LAND USE APPLICATION COMPLETENESS REVIEW

Subject Property: 1105 Front Street NE

Reference Nos.: 24-106451-PLN (Class 3 Site Plan Review, Tentative Subdivision Plan, Class 1 & 2 Adjustment, Class 2 Driveway Approach Permit)

**TENTATIVE PLAT
 THE CANNERY
 FUND
 SALEM, OREGON**

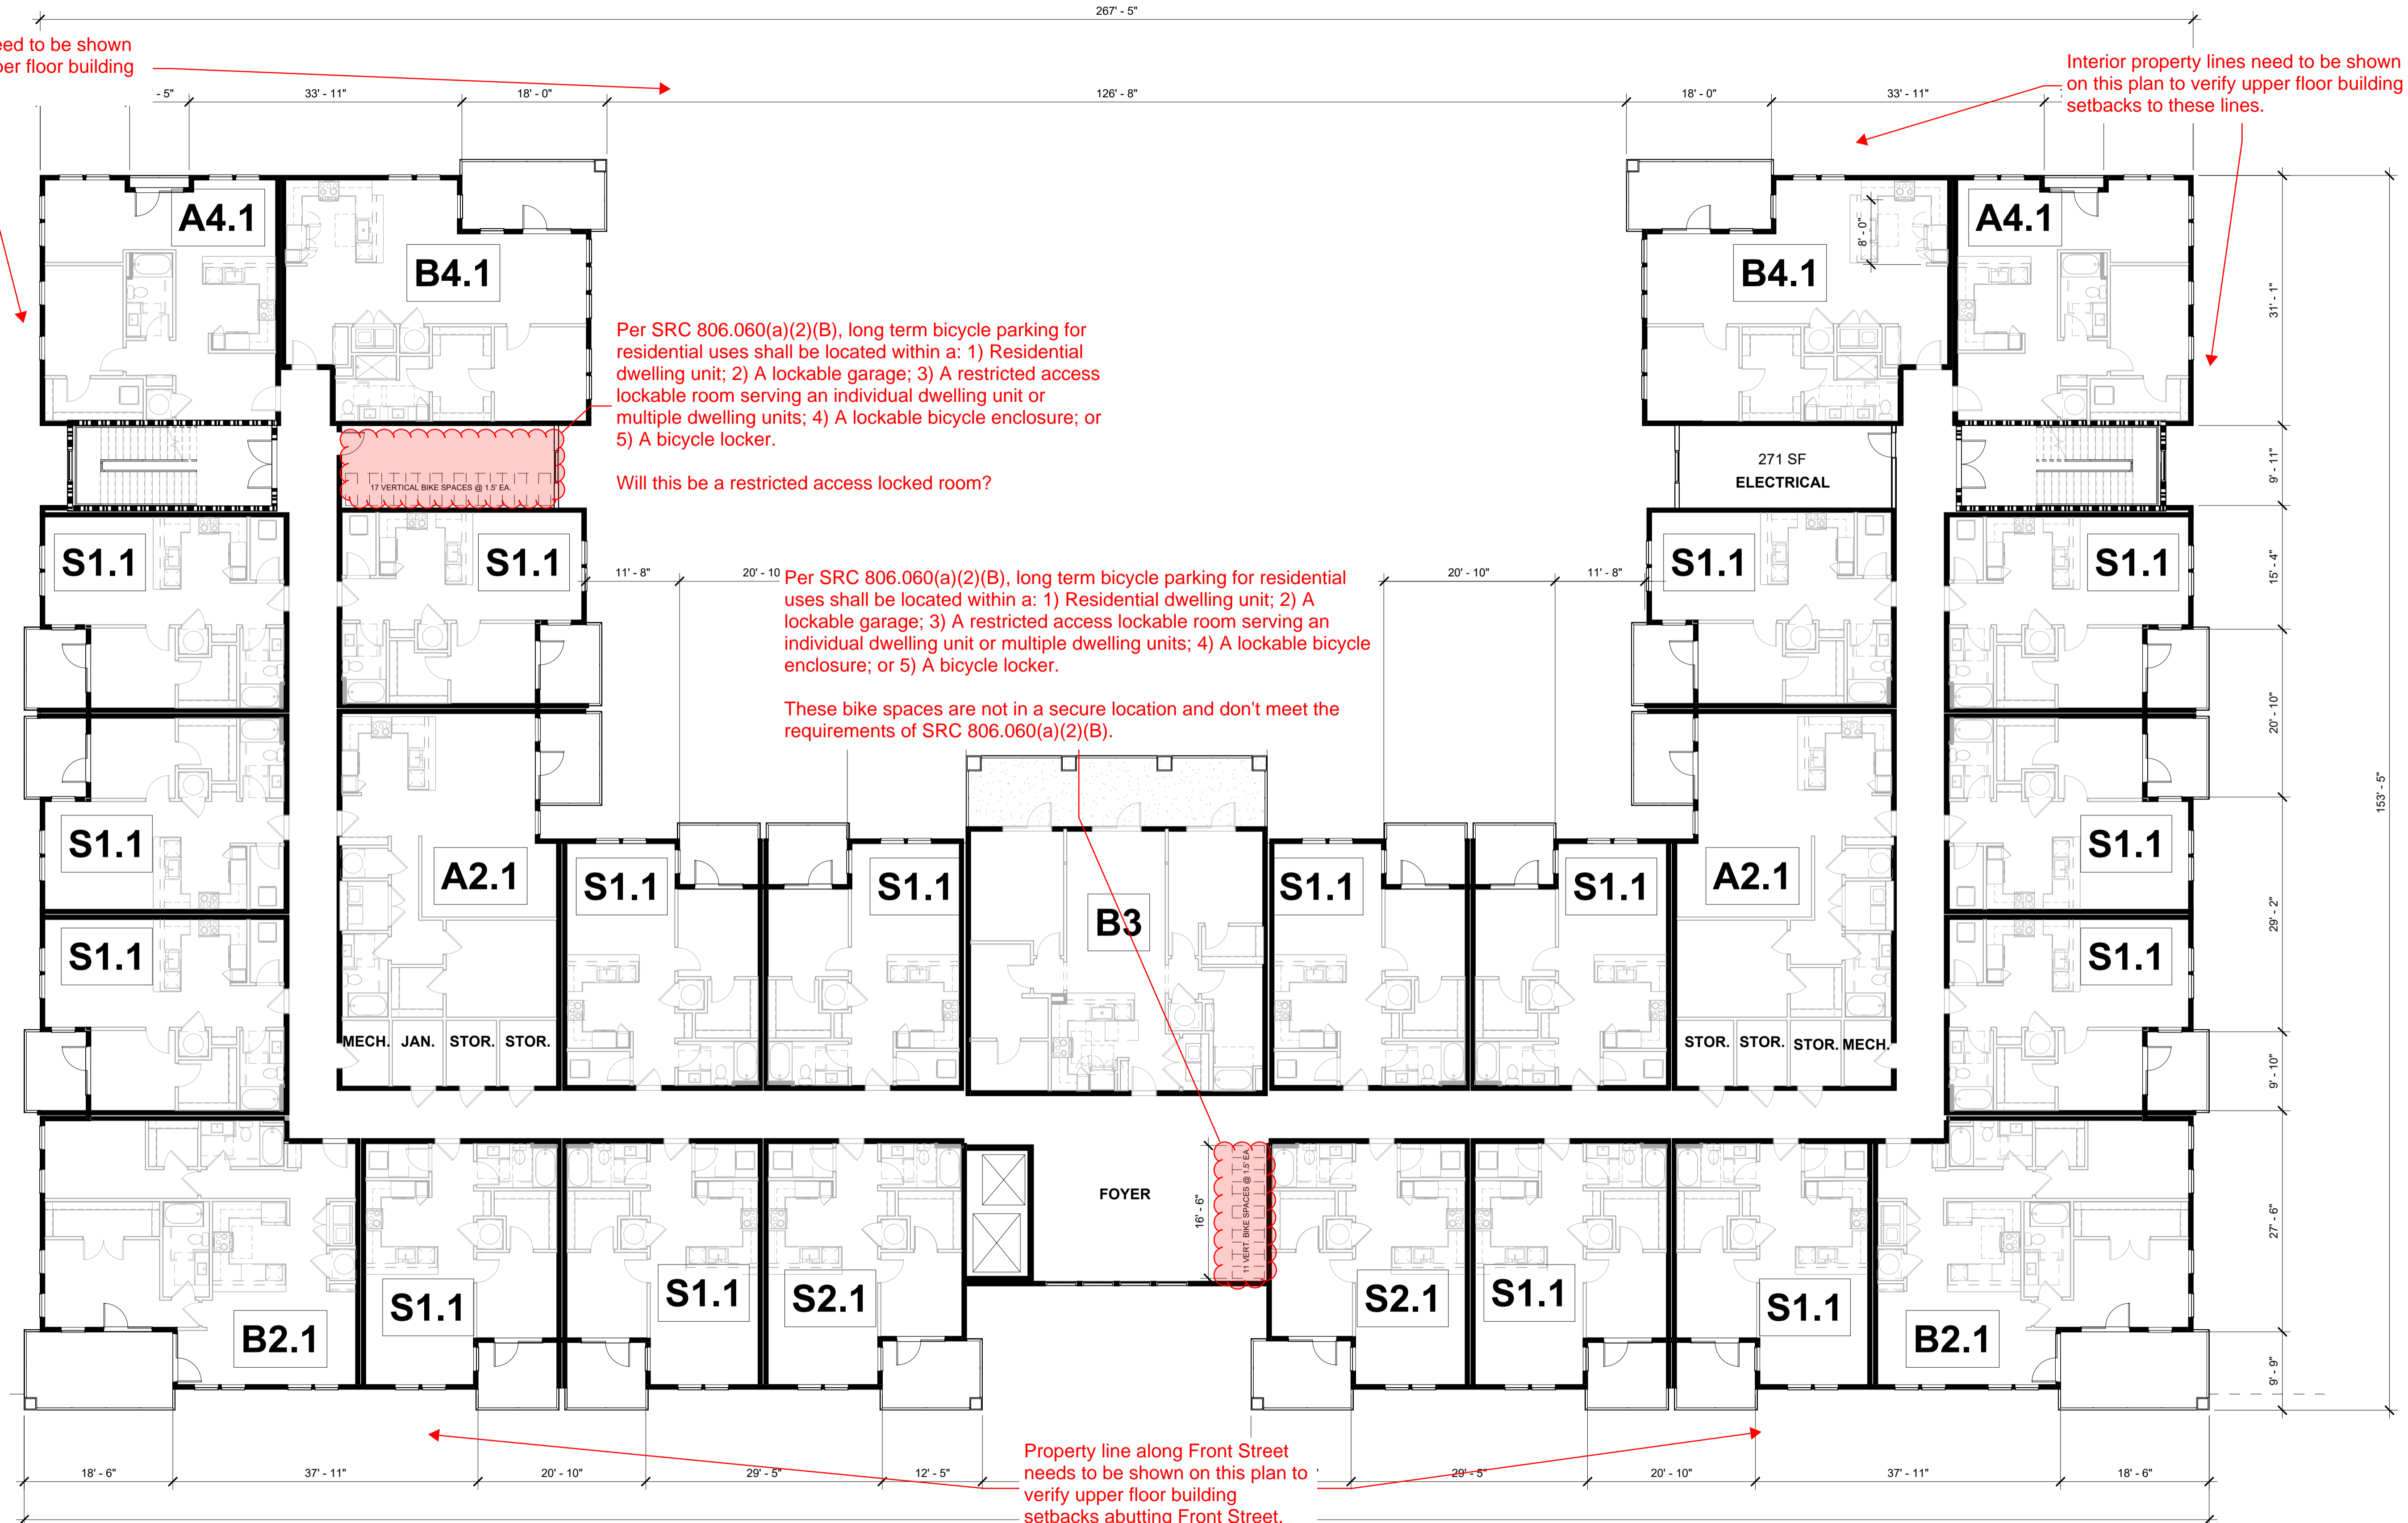
Interior property lines need to be shown on this plan to verify upper floor building setbacks to these lines.

Interior property lines need to be shown on this plan to verify upper floor building setbacks to these lines.

Detail drawing needed showing the layout of each bike space in relation to the proposed vertical bike racks.

Per SRC 806.060(a)(2)(B), long term bicycle parking for residential uses shall be located within a: 1) Residential dwelling unit; 2) A lockable garage; 3) A restricted access lockable room serving an individual dwelling unit or multiple dwelling units; 4) A lockable bicycle enclosure; or 5) A bicycle locker.

These bike spaces are not in a secure location and don't meet the requirements of SRC 806.060(a)(2)(B).

Property line along Front Street needs to be shown on this plan to verify upper floor building setbacks abutting Front Street.

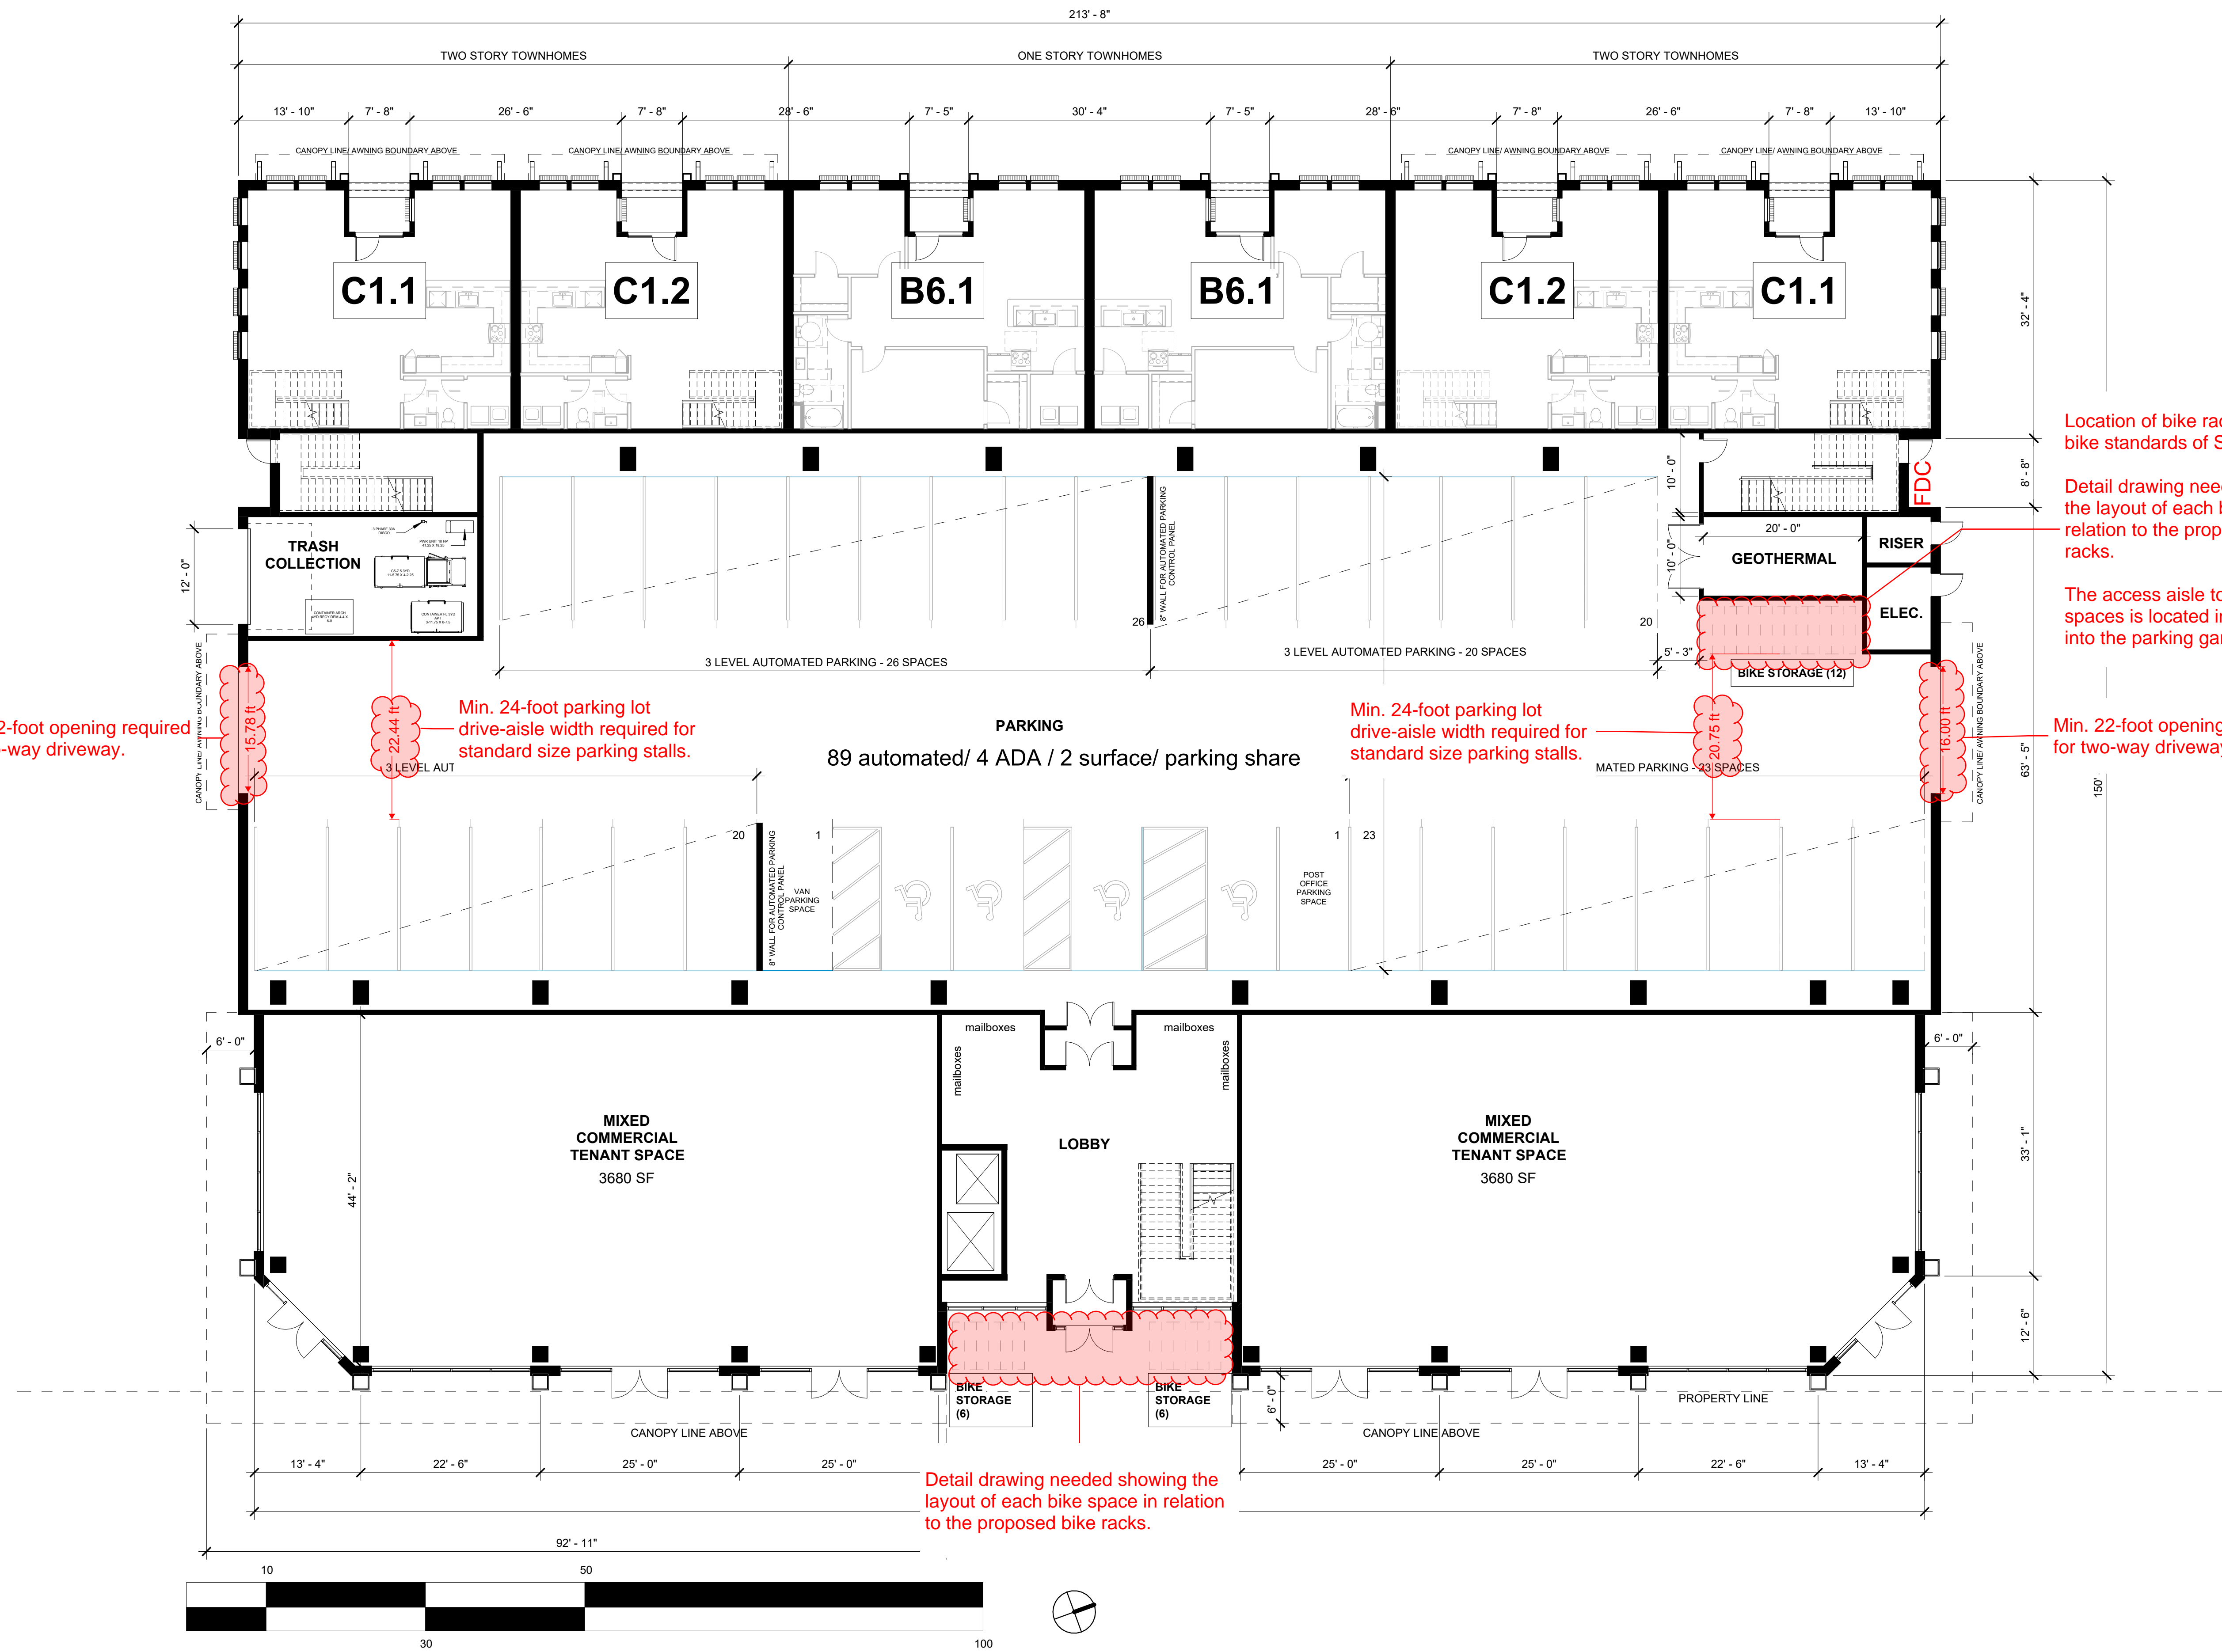
Ground Floor Building Height
 SRC 536.015(g) - Table 536-6 requires buildings with ground floors on primary streets to have a minimum ground floor height of 10 ft. For purposes of this stand ground floor height is measured from the floor to the ceiling of the first floor. The applicant's written statement indicates that the ground floor height of the building is 18 feet. However, in review of the building elevations it looks like the 18-foot height is measured from the floor of the first floor to the floor of the second floor. Confirmation is needed regarding the ground floor height of Buildings 1, 2, and 3 measured from floor to ceiling of the first floor.

Location of bike racks don't meet bike standards of SRC 806.060.

Detail drawing needed showing the layout of each bike space in relation to the proposed bike racks.

The access aisle to get to the bike spaces is located in the drive-aisle into the parking garage.

Min. 22-foot opening required for two-way driveway.

Min. 24-foot parking lot drive-aisle width required for standard size parking stalls.
